WEST END REGIONAL NAVIGATION CENTER PROJECT
BID NO.: DE-26-222-SB

Addendum No. 2 Information
June 16, 2026

4.1 **Revised** "WEST END REGIONAL NAVIGATION CENTER" Plan Sheets are hereby included and shall replace the previously released "WEST END REGIONAL NAVIGATION CENTER" Plan Sheets. Changes to Plans include:

A-0.3

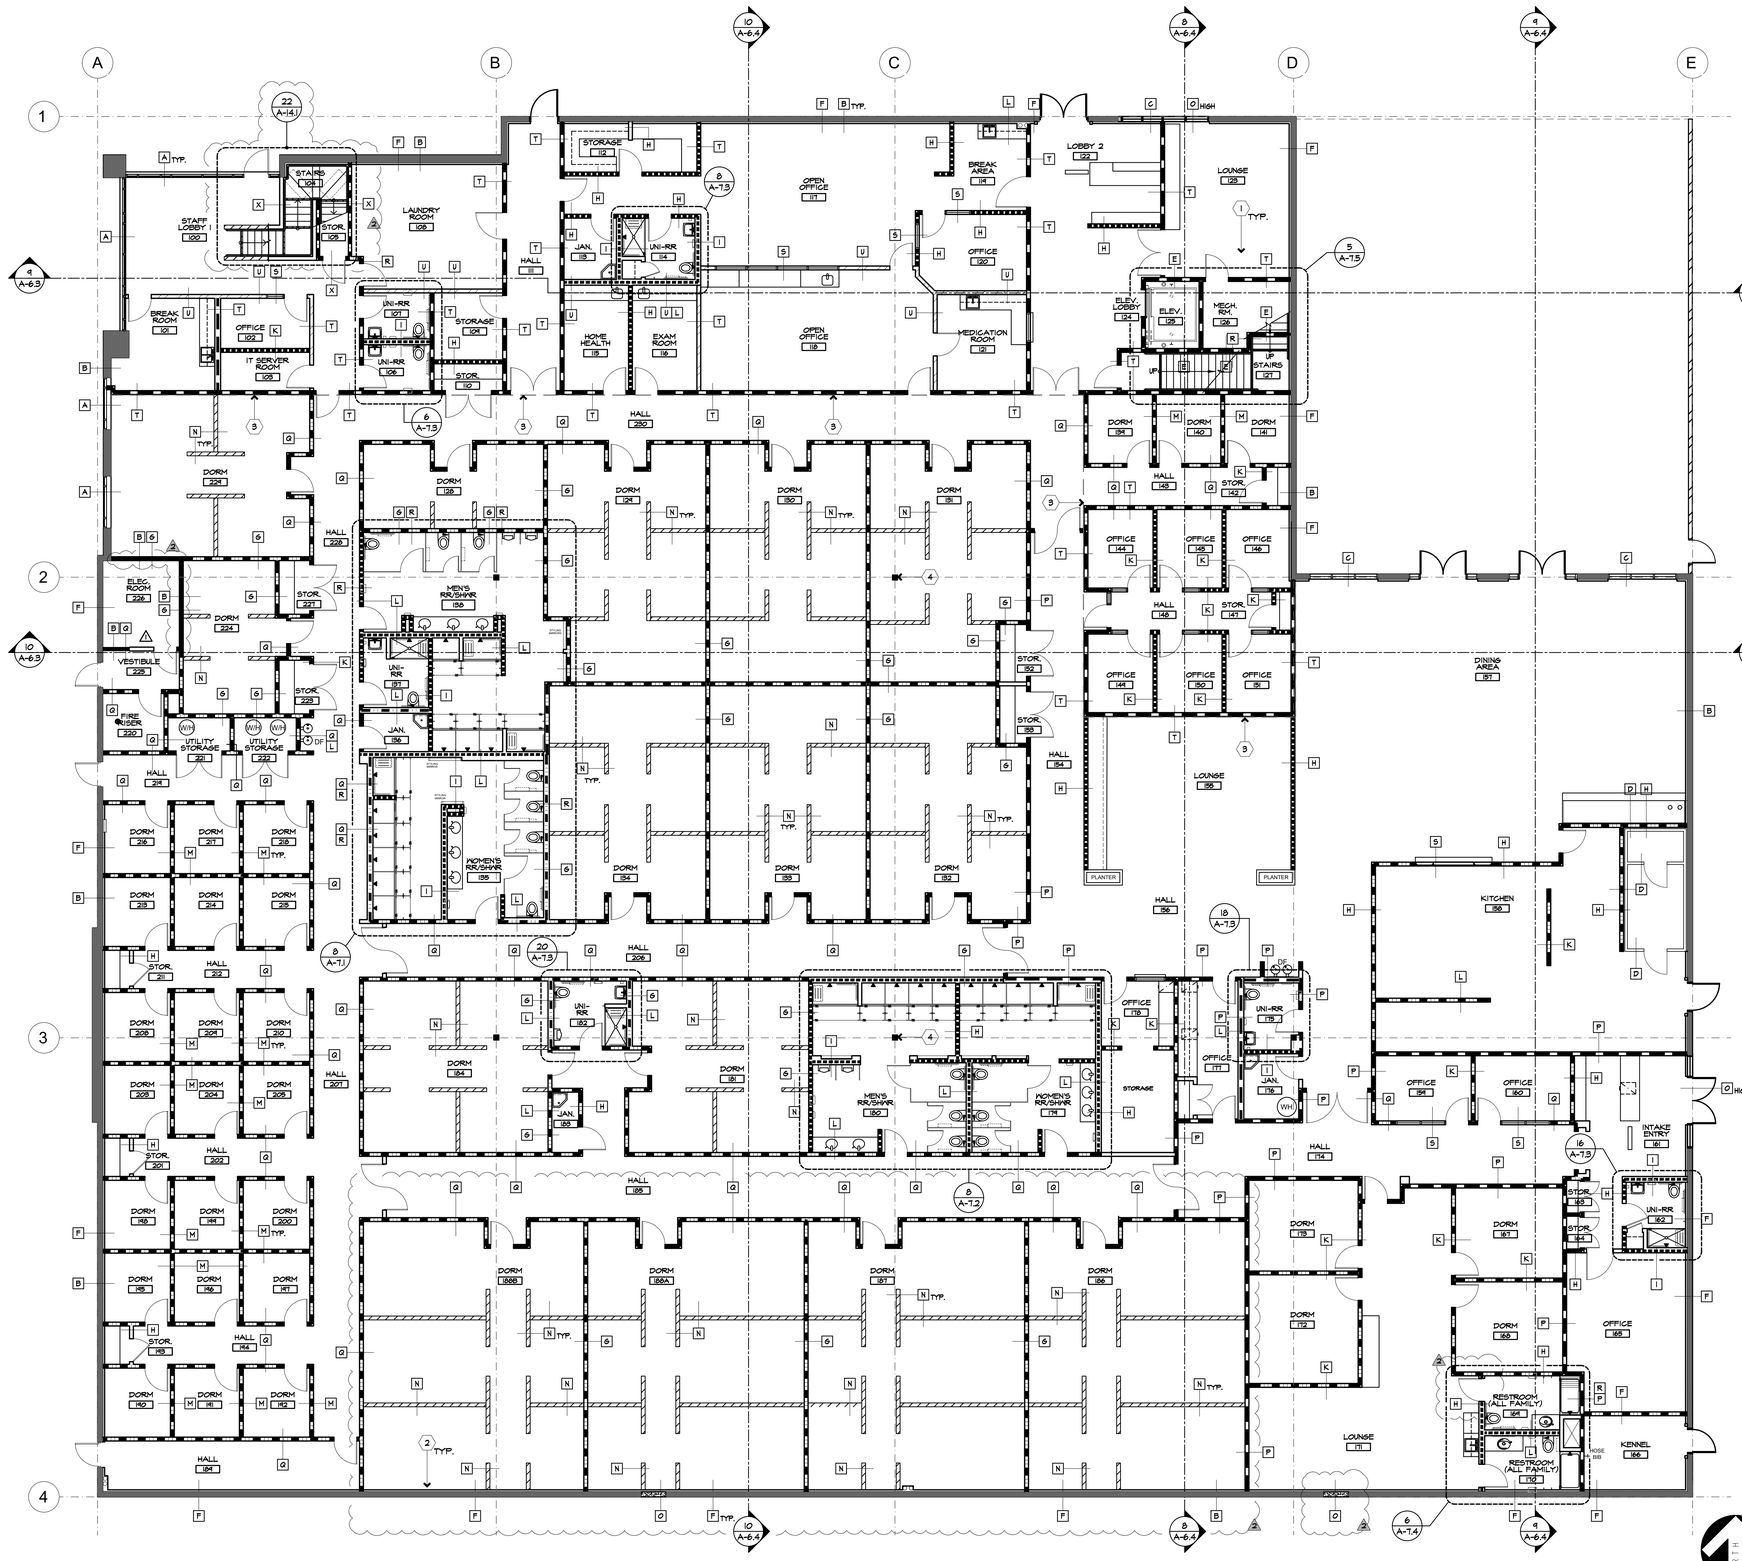
r. **Sheet A-0.2:** Clarify demolition at west stairs. Clarify demolition scope at south-side dorm room area.
s. **Sheet A-0.3:** Clarify demolition at west stairs. Clarify plan keynote No. 2. Clarify plan keynote No. 7.

A-1.0

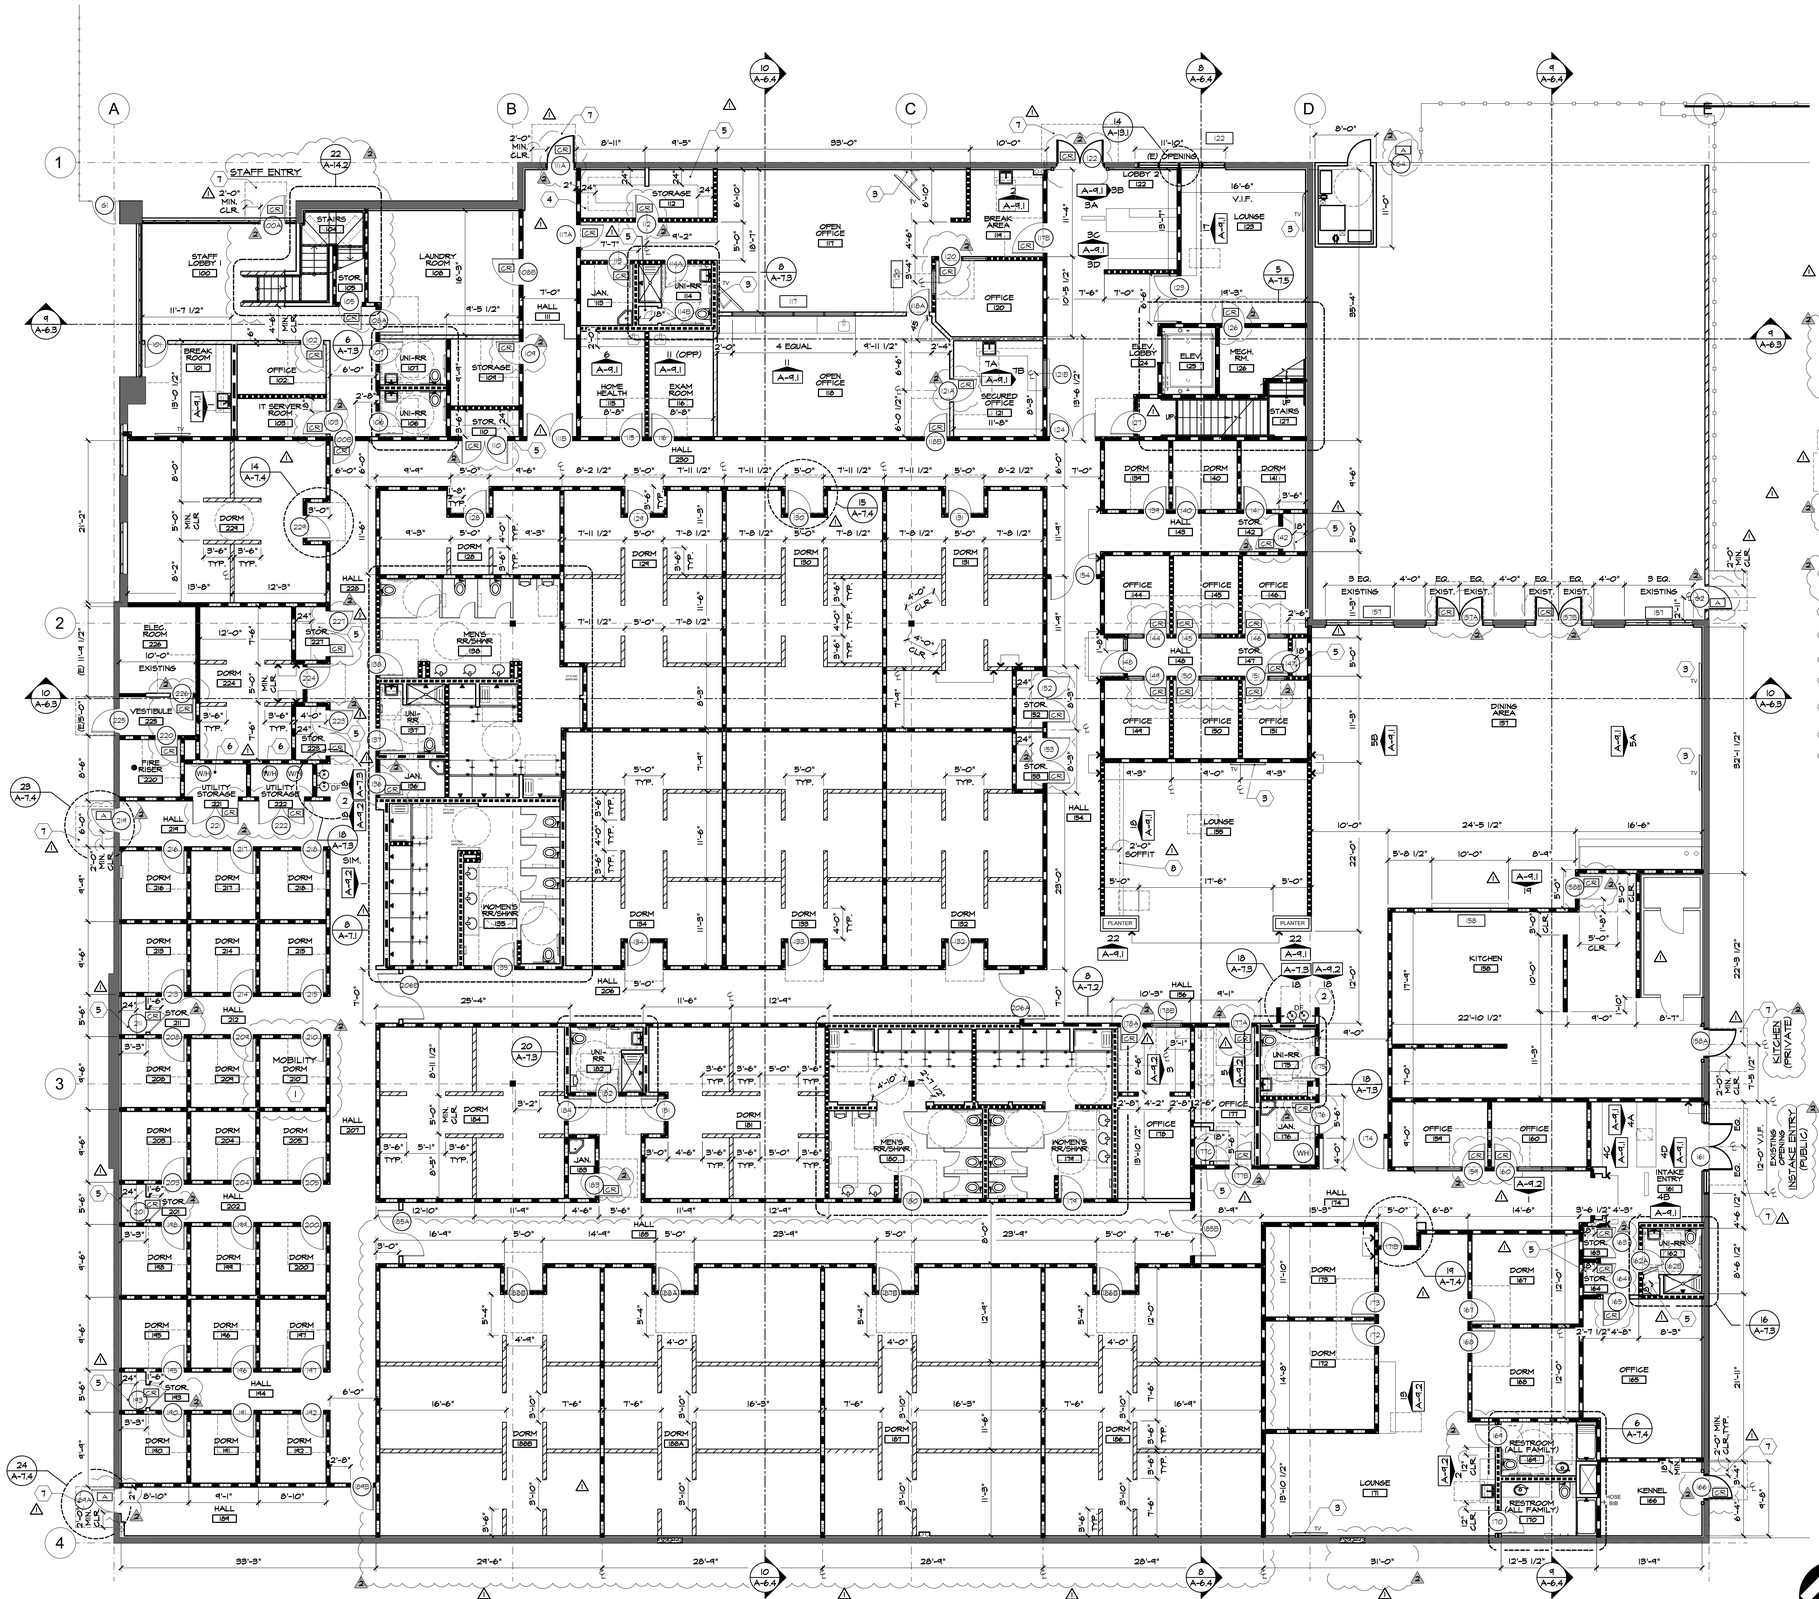
t. **Sheet A-1.0:** Clarify reconfigured west stair. Clarify reconfigured south dorm rooms 188A, 188B, 187, and 186; omit south egress doors at each room. Omit south egress door at Room 171. Add new wall type “X” to wall legend.

A-1.1

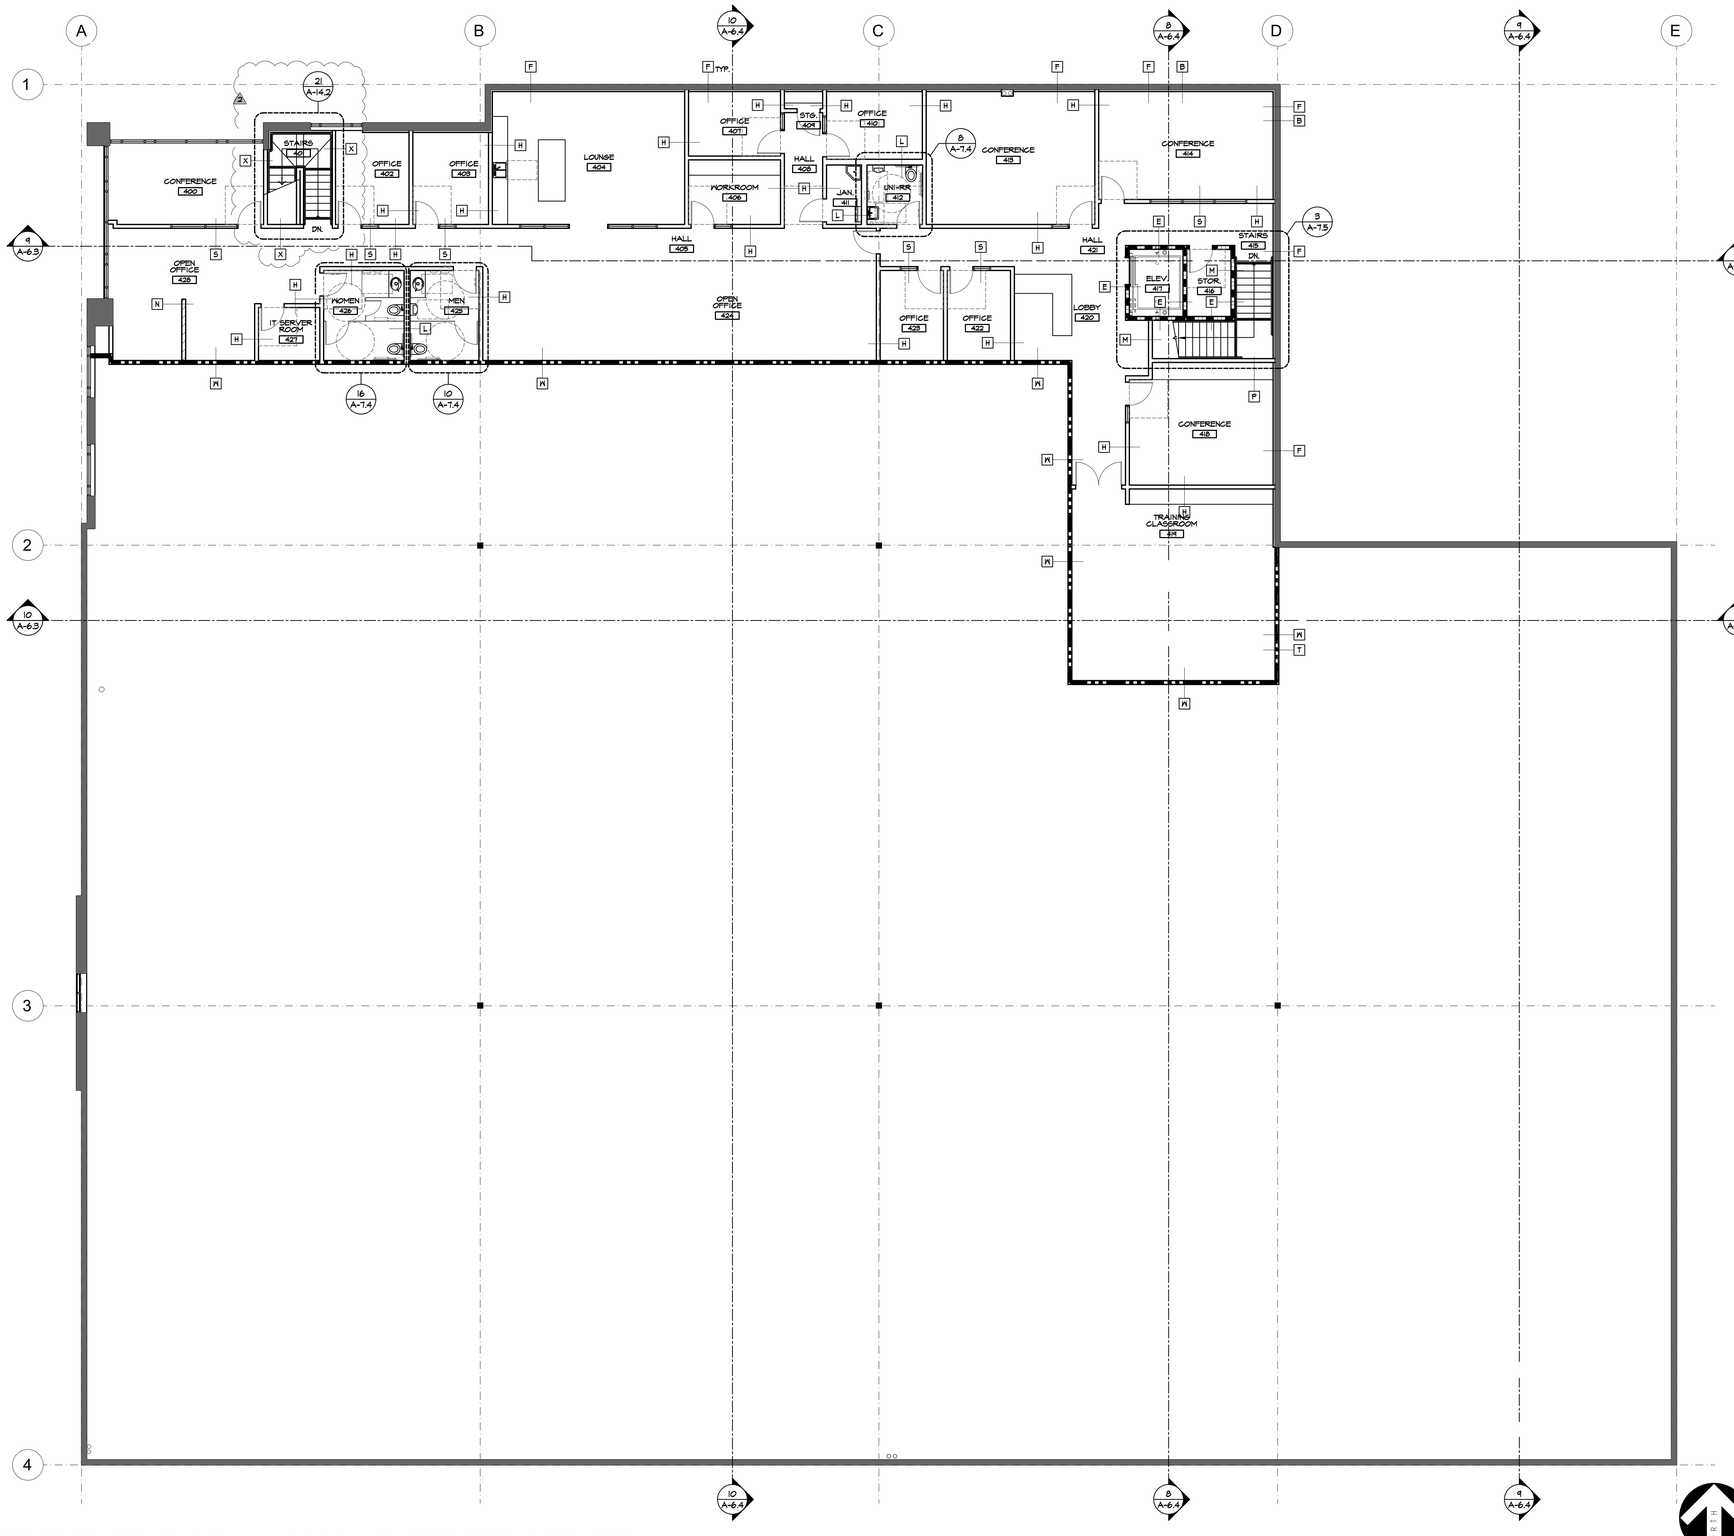
u. **Sheet A-1.1:** Add additional card-reader location to doors throughout. Clarify reconfigured south dorm rooms 188A, 188B, 187, and 186; omit south egress doors at each room. Omit south egress door at Room 171. Clarify new designated Mobility Dorm Room 210 and add new General Note No. 13 with requirements. Revise room name for Room 121. Clarify “alarmed”-door locations throughout. Clarify reconfigured west stairs.

A-1.3

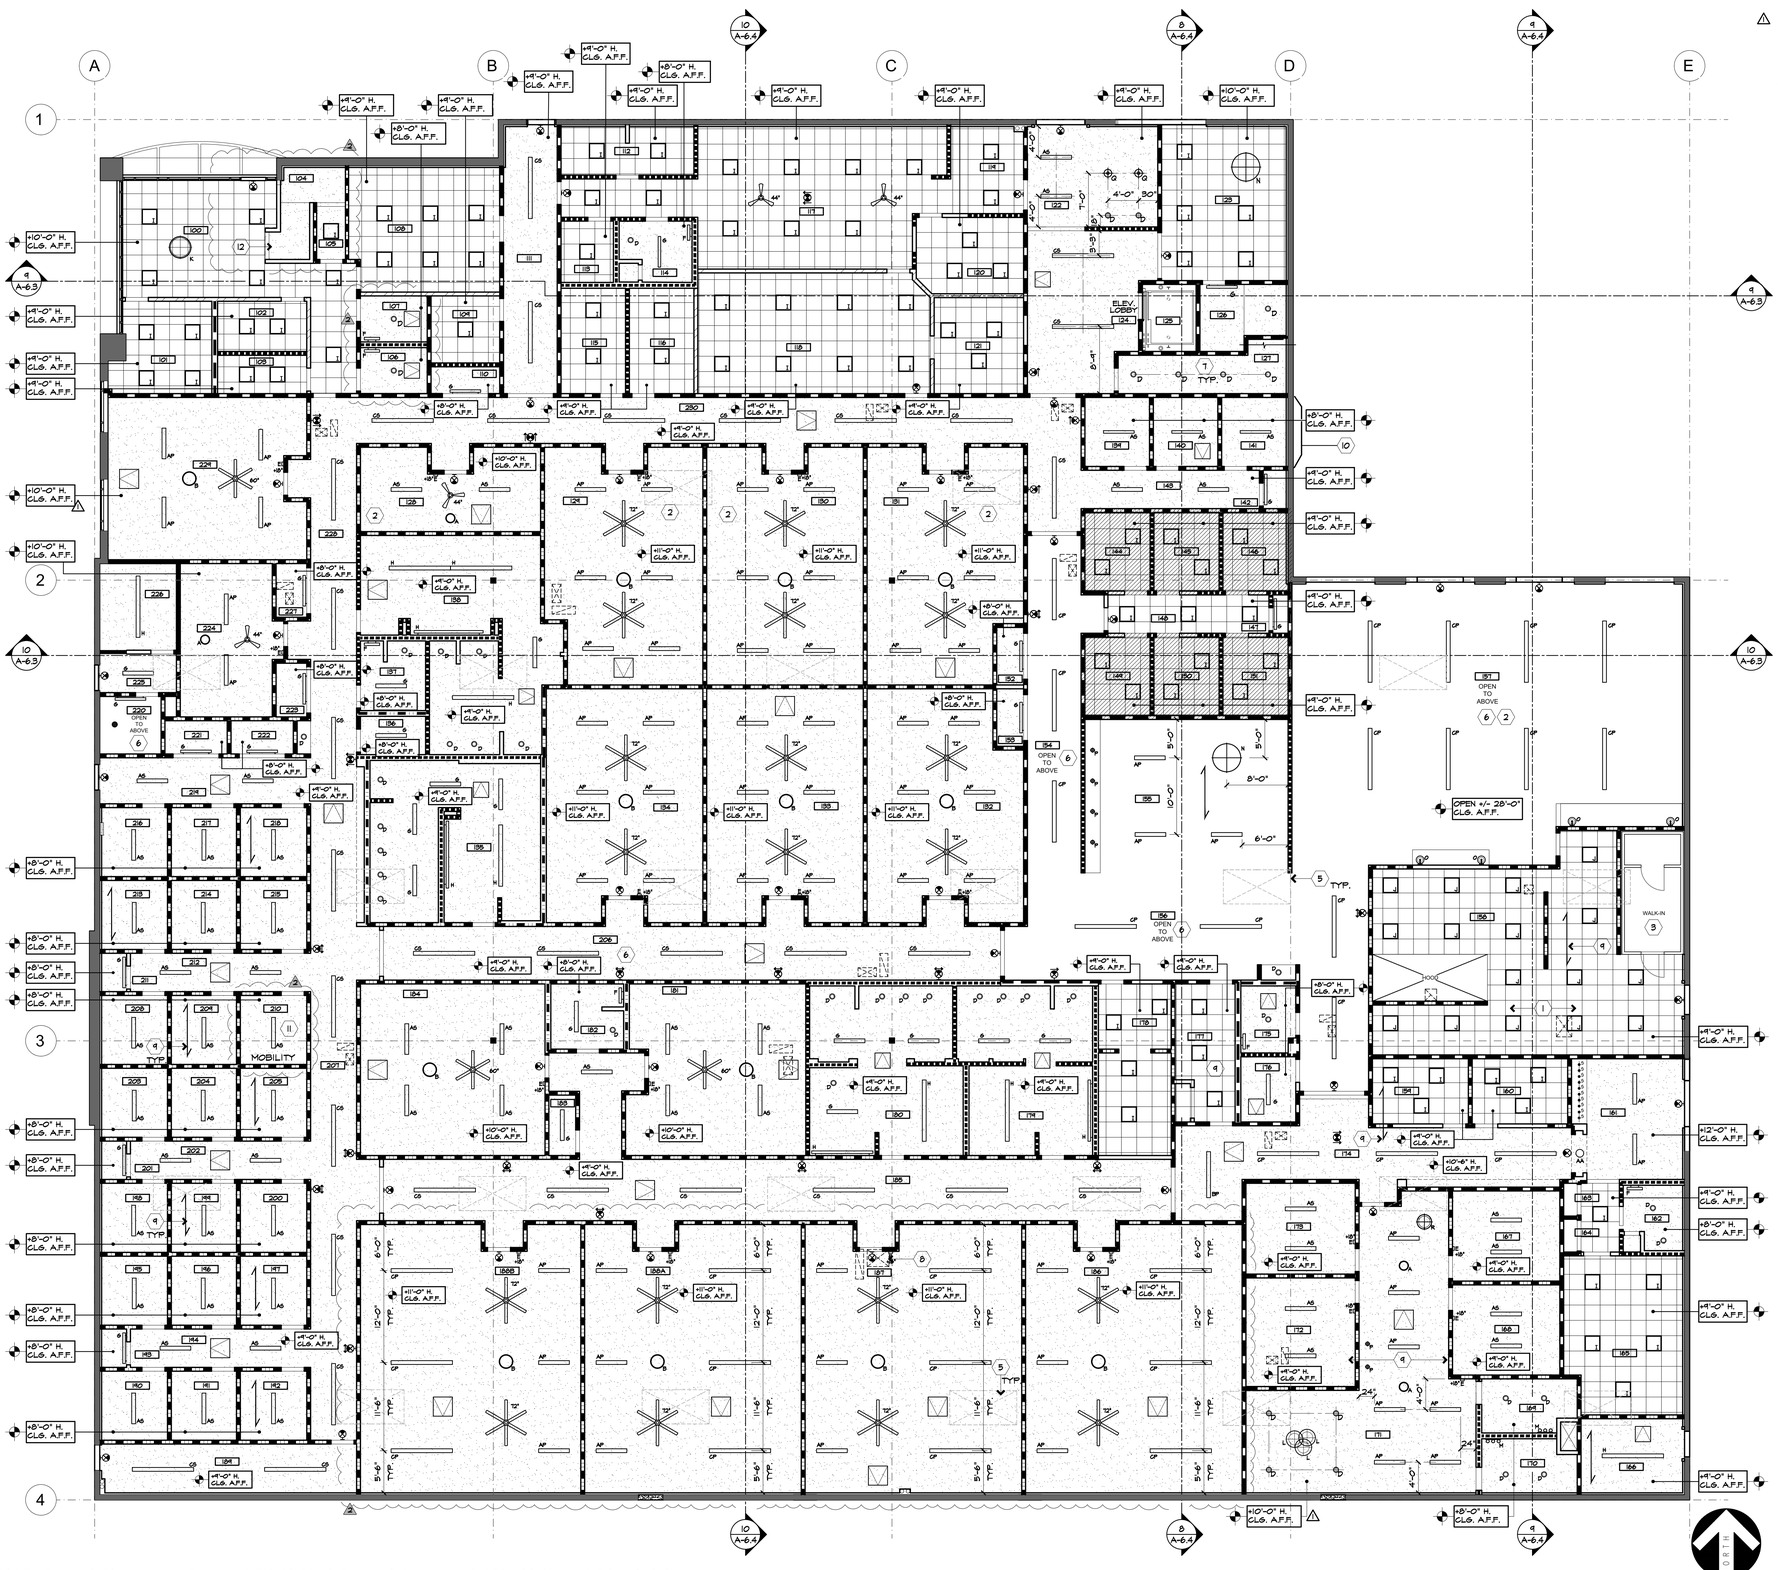
v. **Sheet A-1.2:** Clarify reconfigured west stair. Clarify wall type “X” in wall legend.
w. **Sheet A-1.3:** Add additional card-reader locations to doors throughout. Clarify reconfigured west stairs.
